# 1.0 Introduction

Following improved access to the rear of 26 Denmark Street and the East Gable of 22 Denmark Place, we have identified a number of discovery item issues that are addressed in the corresponding application drawings as well as summarised within this document.

## 26 Denmark Street

# 3.0 Existing Render Removal

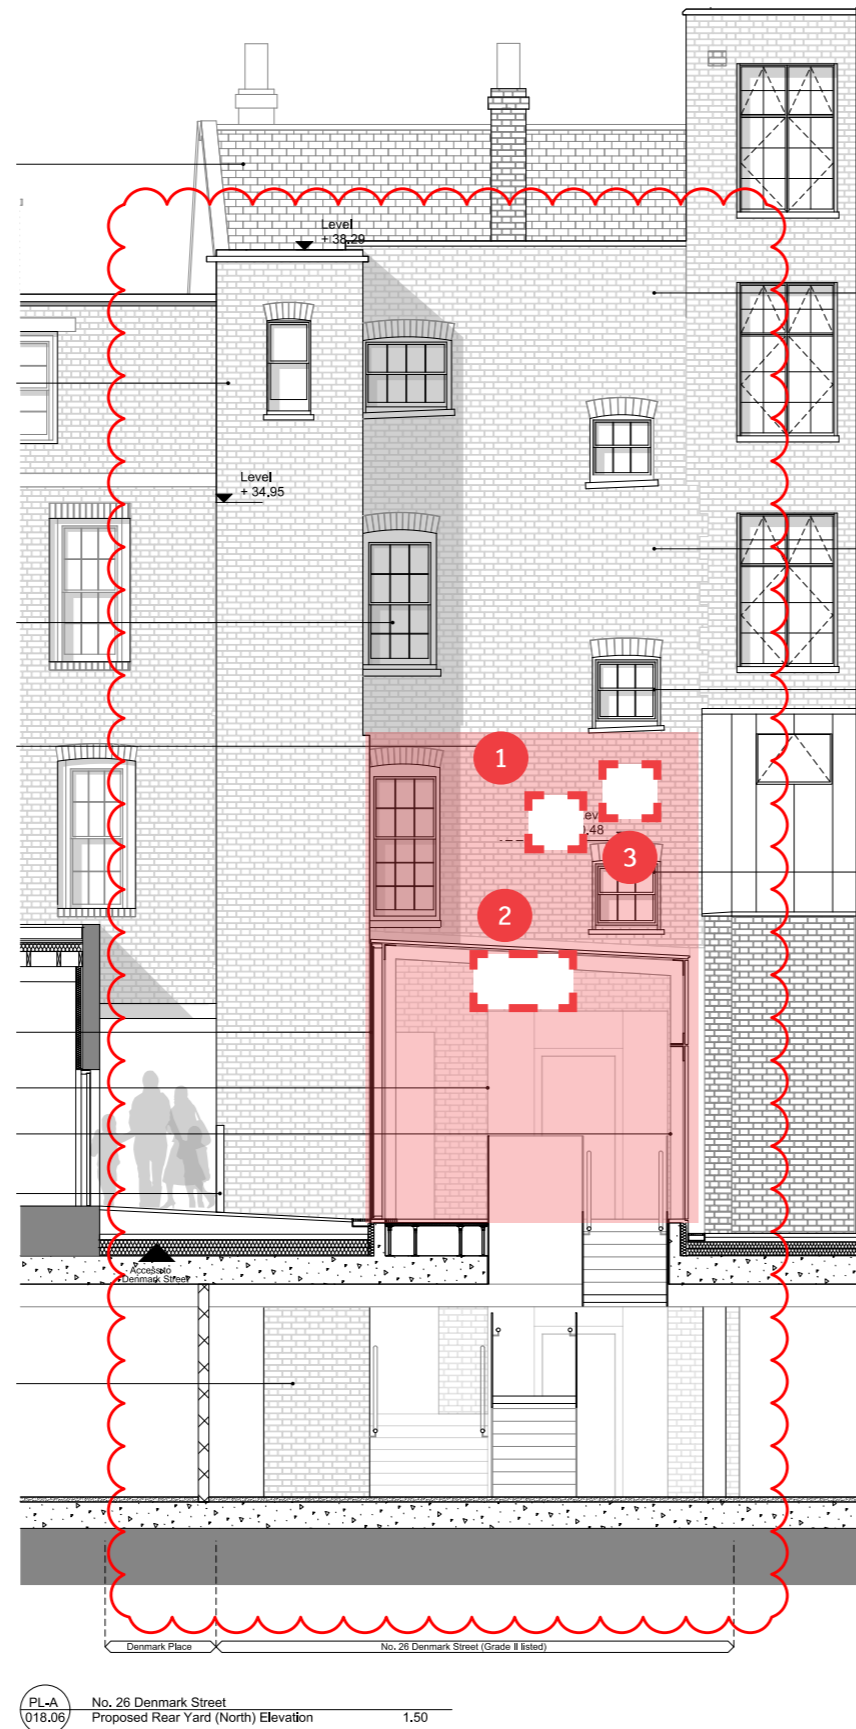
Samples areas of existing render have been removed in three locations.

This has revealed masonry of varying quality. It is assumed that historically the facing brickwork has been scabbled to provide a key for the render.

As a result the brickwork below the existing render is not of quality to expose, without substantial cutting out and replacement of existing brickwork, which would significantly affect the existing building fabric.

# 4.0 Proposed Solution

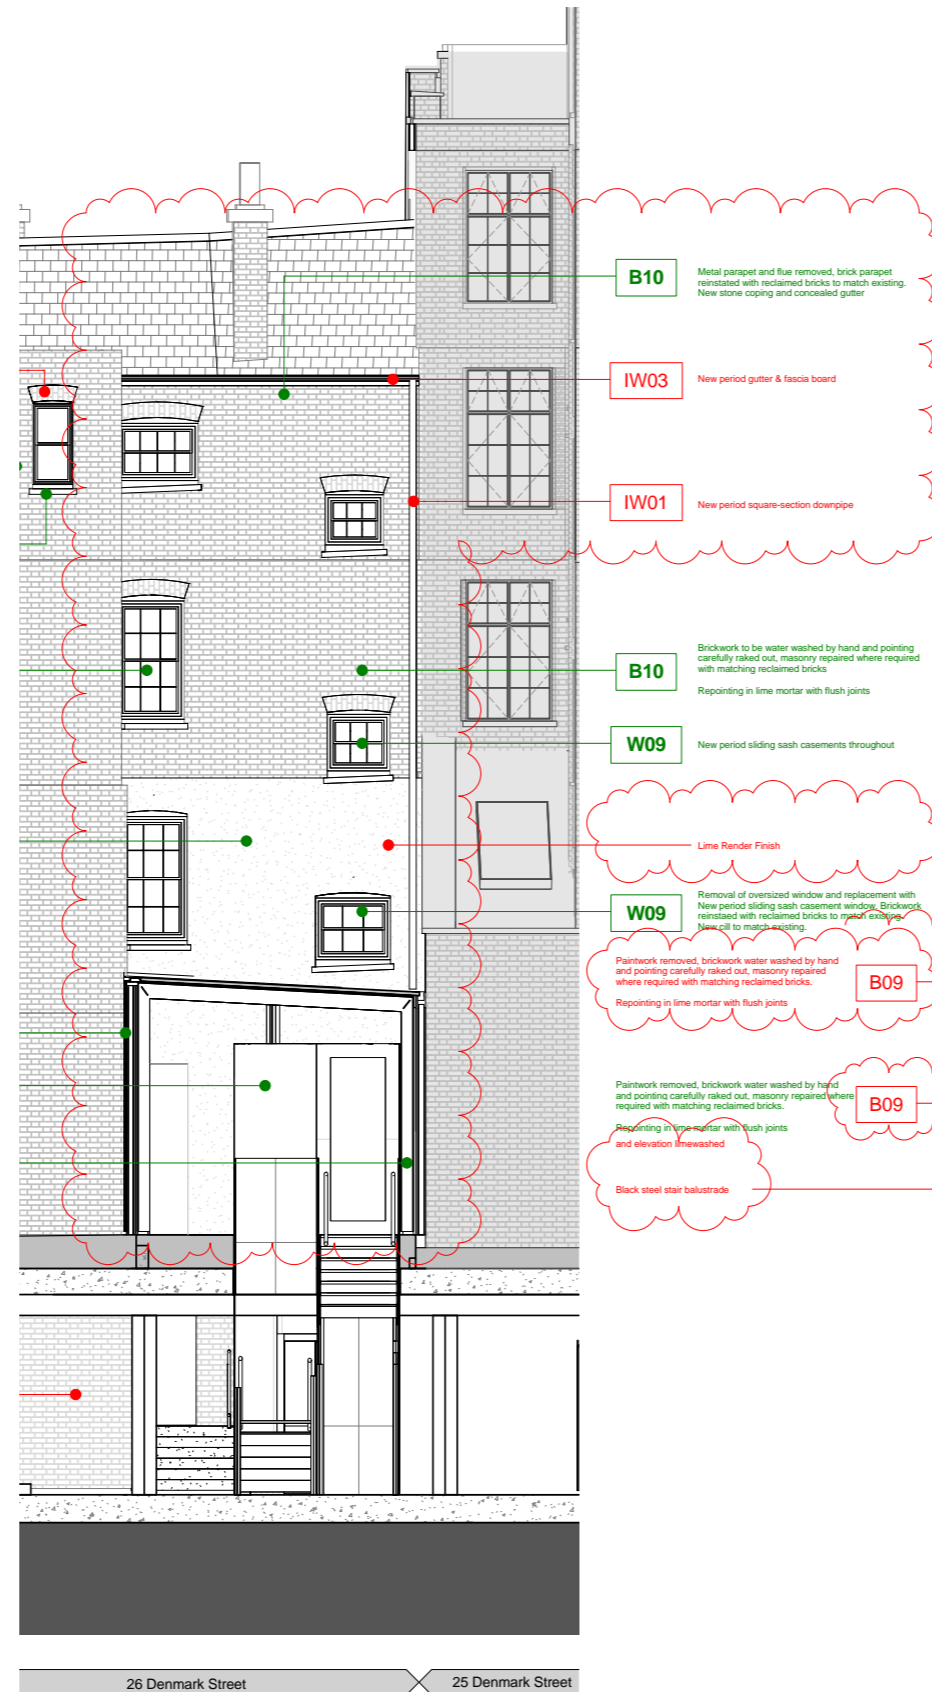
As can be seen overleaf, the existing masonry is in poor condition and not suitable for facing brickwork.

Leaving the existing render in place may lead to water becoming trapped behind the render which could cause degradation to the existing brickwork.

We plan to remove the existing cementitious render and address any structural issues with the concealed masonry.

The existing render will be removed carefully to guard against any further damage to the brickwork.

We propose to finish the existing scabbled brickwork with a lime render finish to replace the existing cementitious render.

We propose a lime render in order to protect the existing friable scabbled brickwork from weather damage, whilst also providing a more period appropriate finish than the existing cementitious render.

## 5.0 Existing Roof Gutter

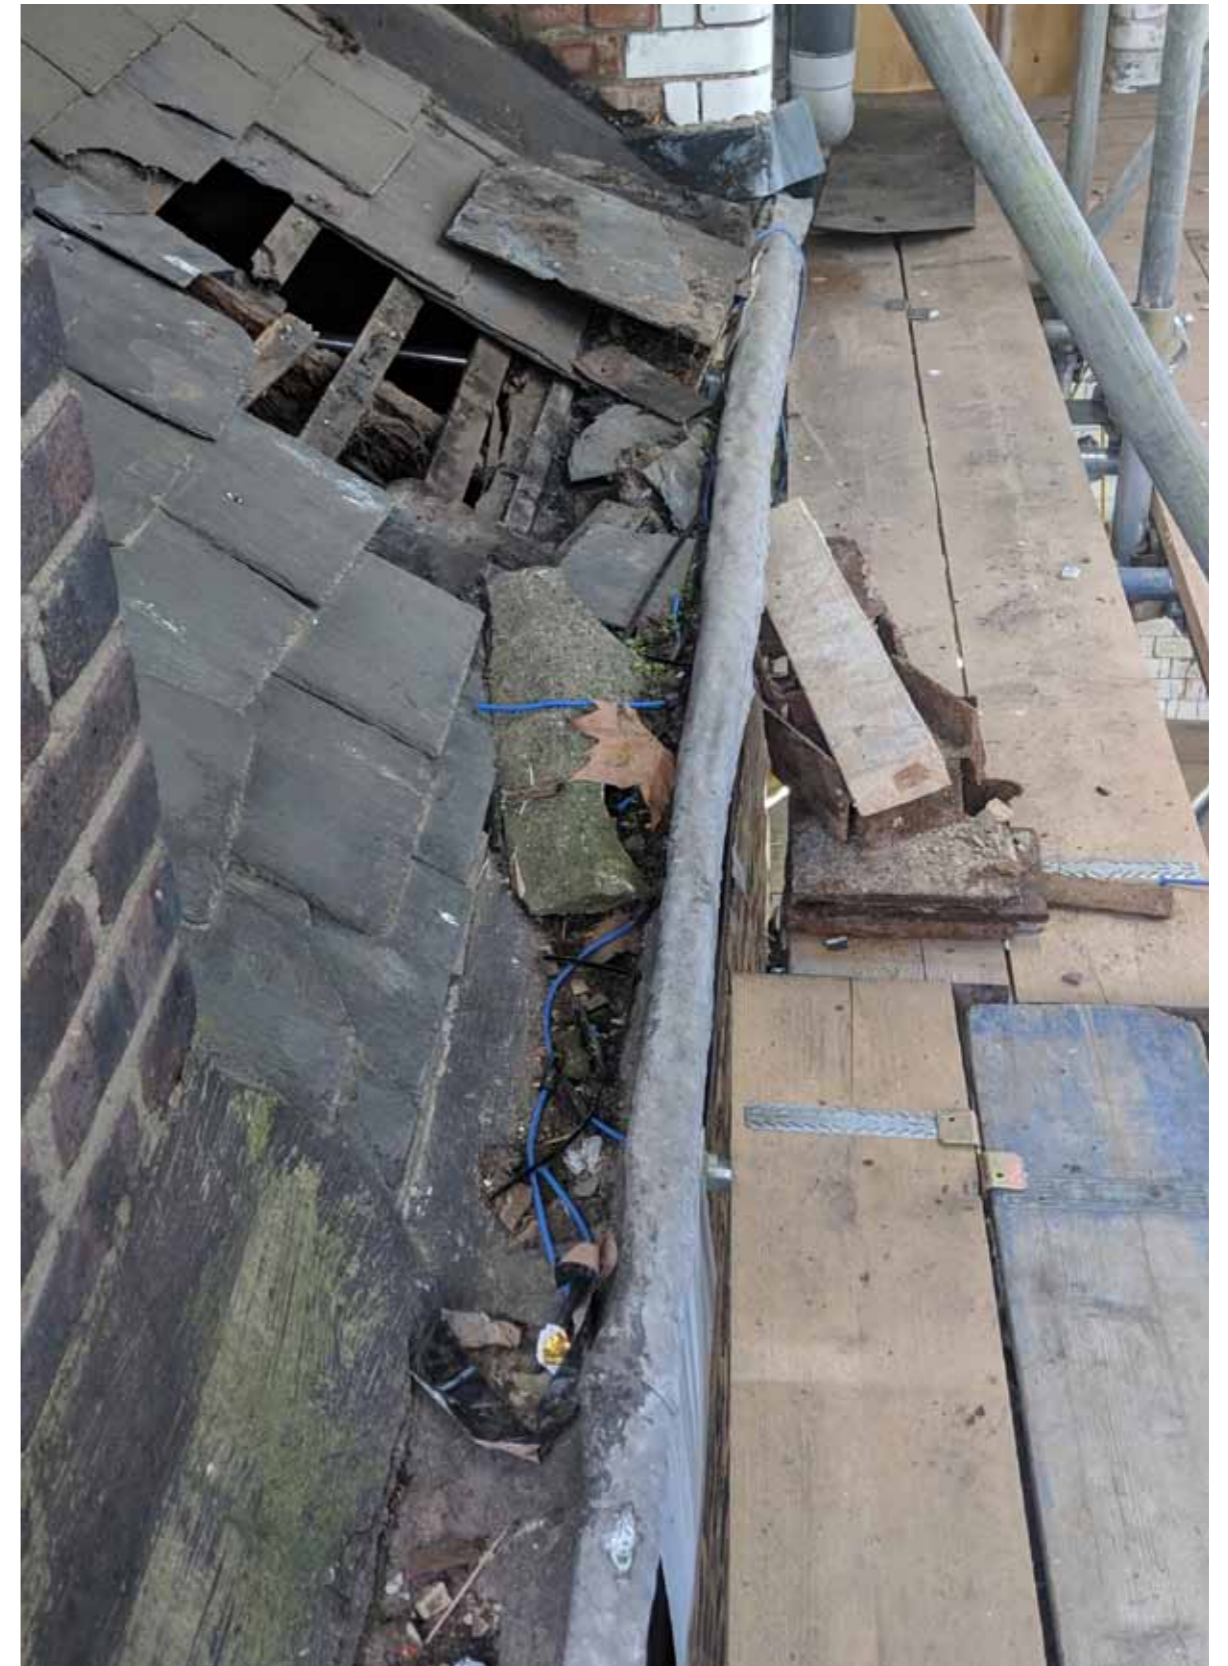
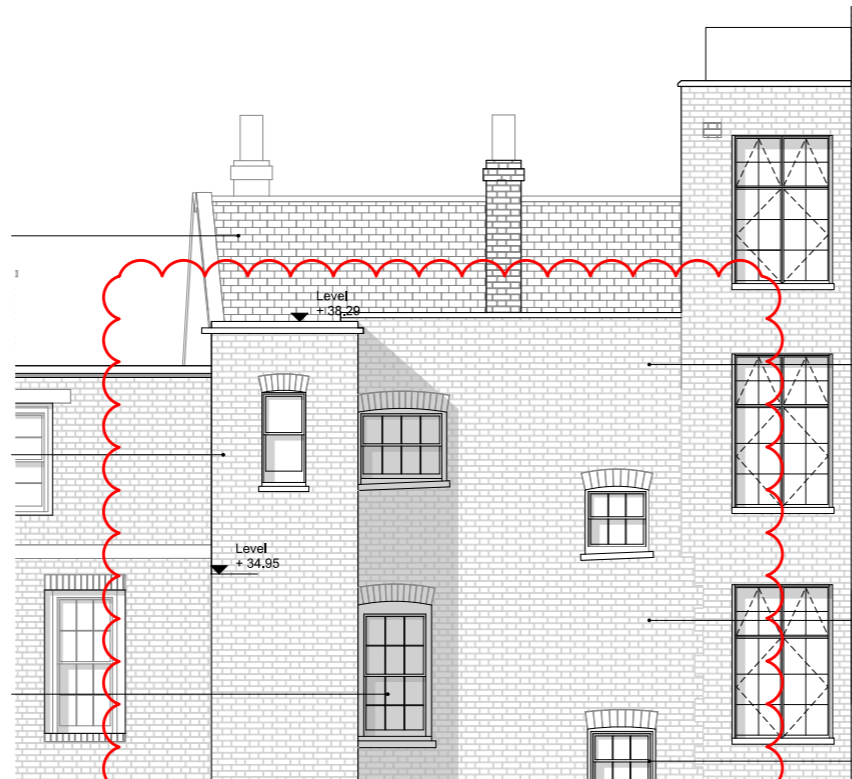
The approved scheme involves the removal of the existing metal parapet with a brick parapet installed in its place.

The brick parapet would conceal a box gutter behind.

Following the erection of the scaffold we have been able to assess the area.

The existing roof arrangement prevents a brick parapet with box gutter being installed due to the current arrangement.

To achieve the detail as originally consented we would need to reset the roof structure to accommodate the box gutter behind the new brick parapet.

Extract of Consented Elevation

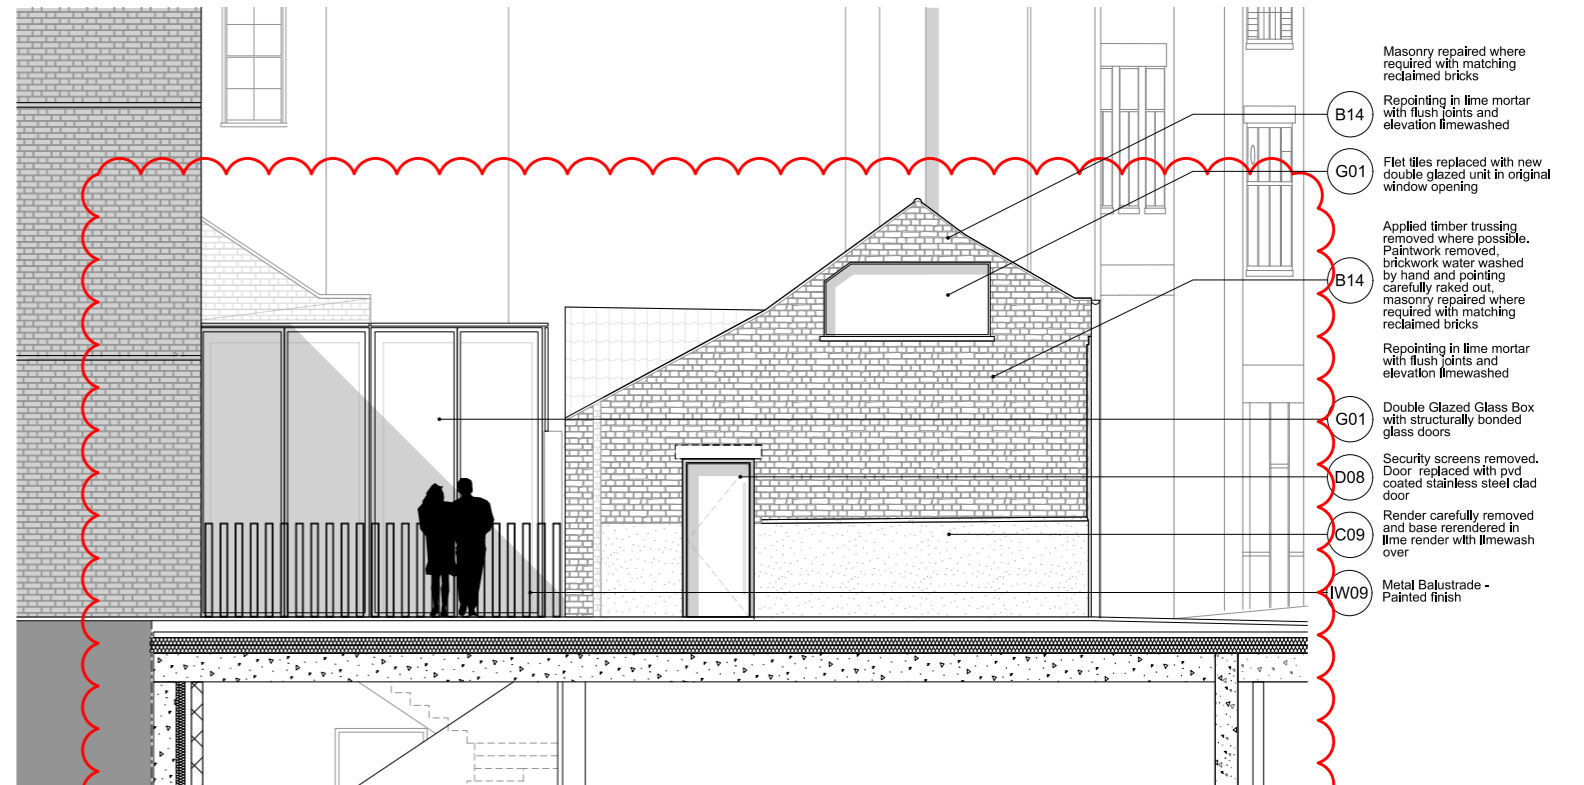
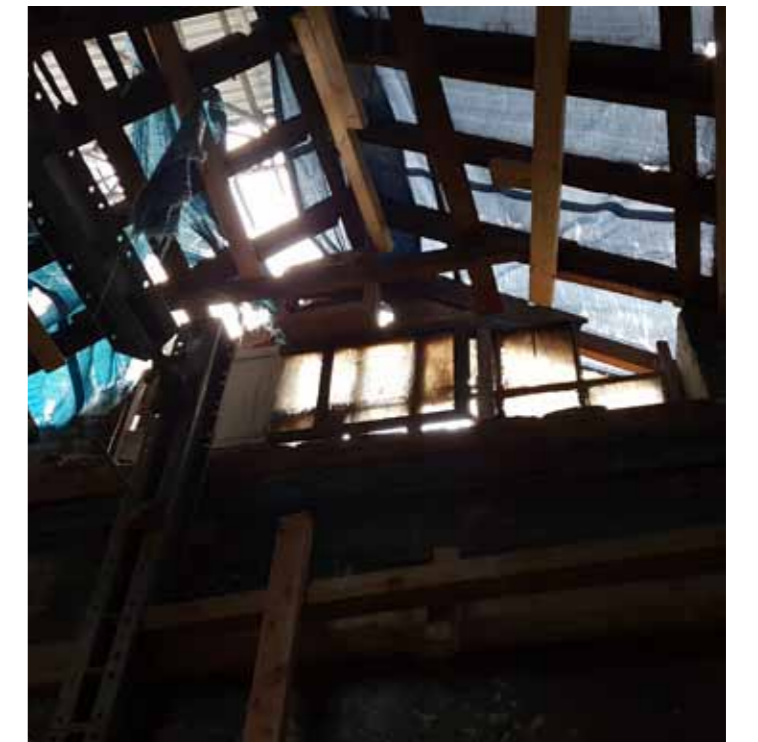
Following the removal of the existing felt tiles consented under 2015/6937/L, and the erection of scaffolding, we have been provided better access to properly assess the existing gable wall and window.

3 The existing window appears to be not have been originally for the building - this is evident from the window frame being cut at corners to fit the existing roof profile

The removal of the felt tiles has revealed that there is no facing masonry above the existing, as previously expected. Present is tongue and groove timber boarding

4 The removal of the existing felt tiles has revealed a embedded timber, spanning across the elevation

Extract of Proposed Elevation

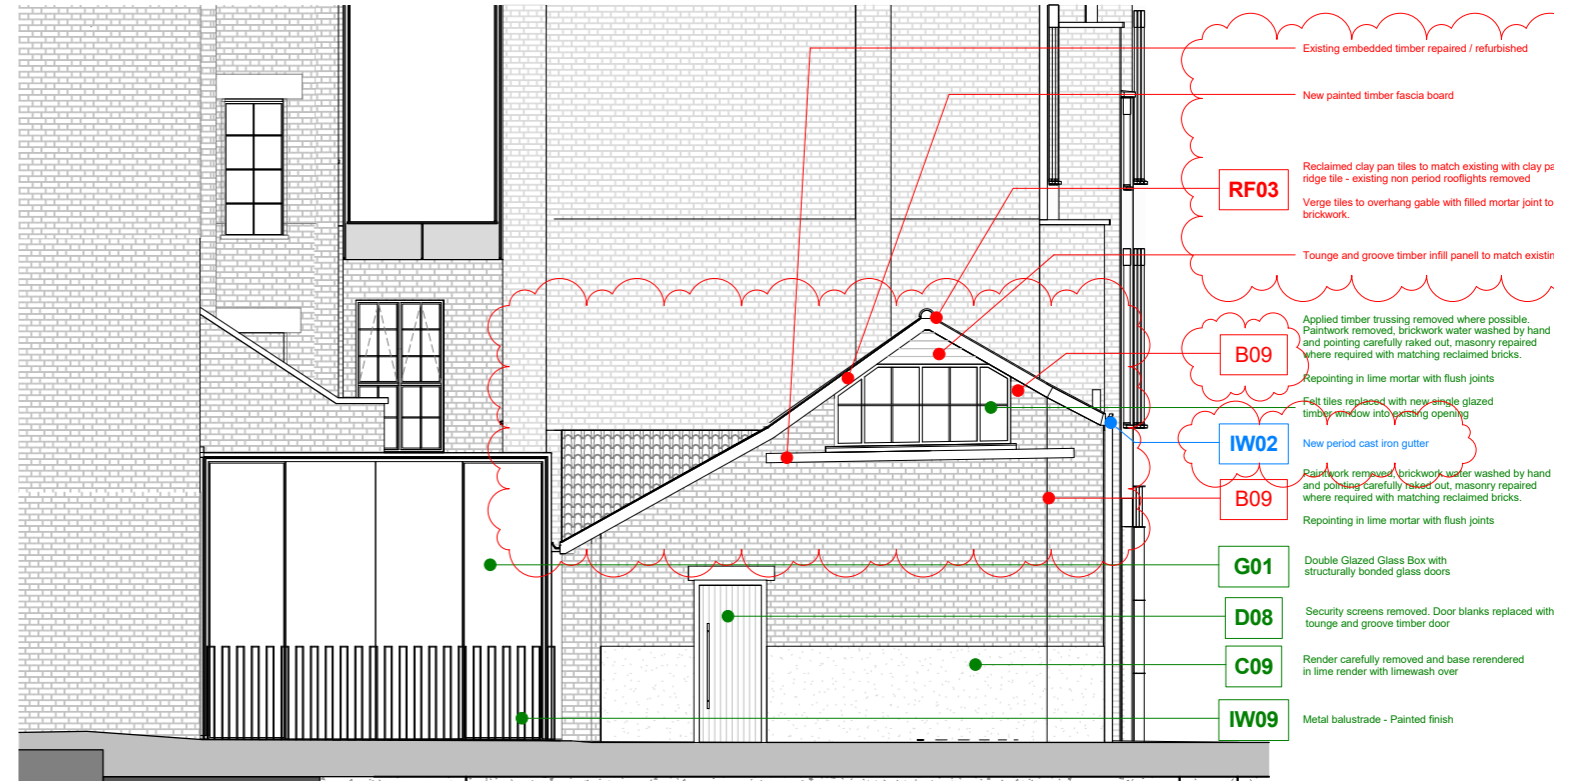
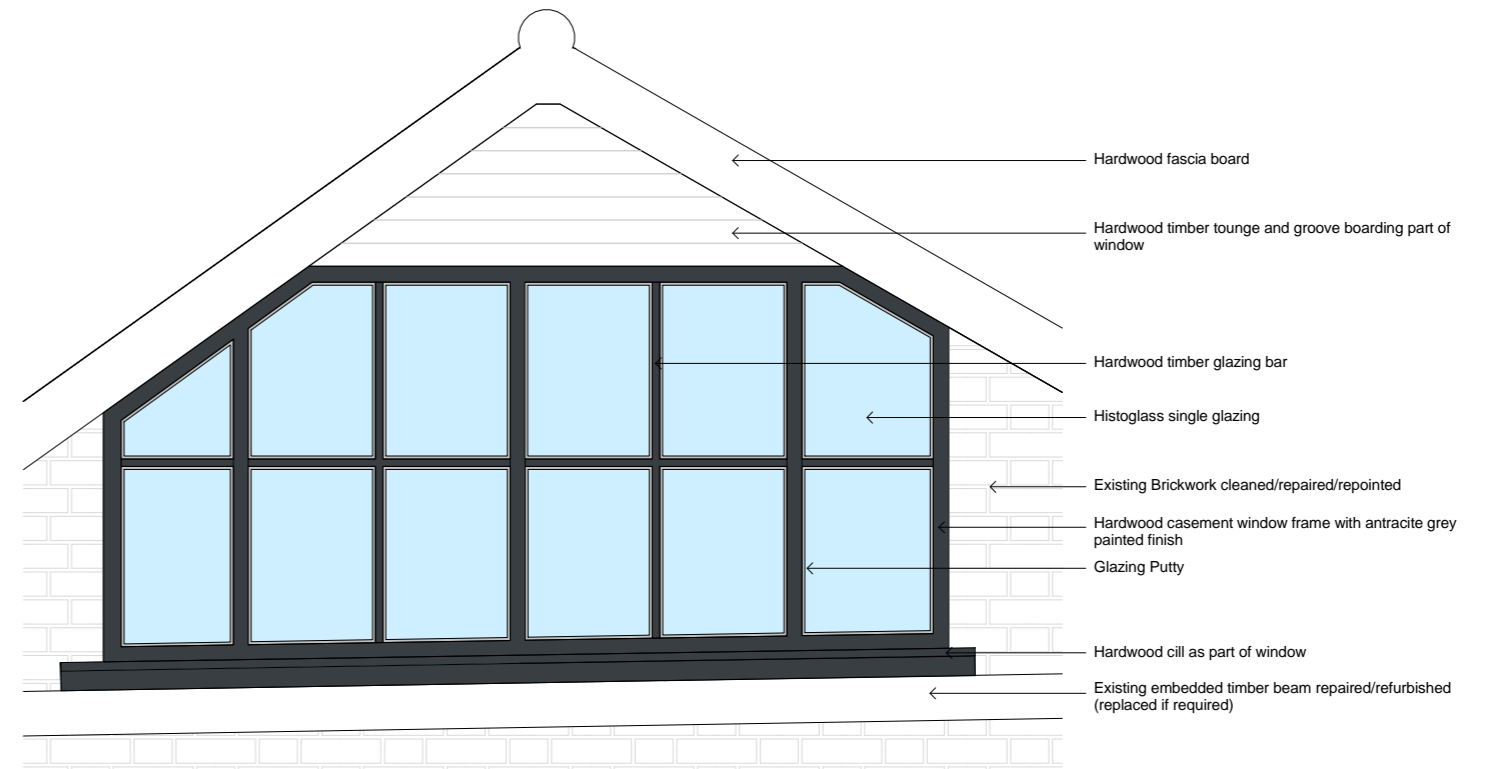
Following assessment of the existing building we propose the below alterations to better reflect the existing buildings fabric

- 3 New timber framed window with infill tongue and groove timber boarding above to reflect the existing arrangement

Fascia board has been added to the elevation to conceal the roof structure which would otherwise be visible

- 4 The existing embedded timber will be retained in place and repaired/refurbished.

This retention of the embedded timber is subject to specialist contractor assessment to whether this can be retained. In the event that the beam is irreparable the beam will be replaced to match the existing.
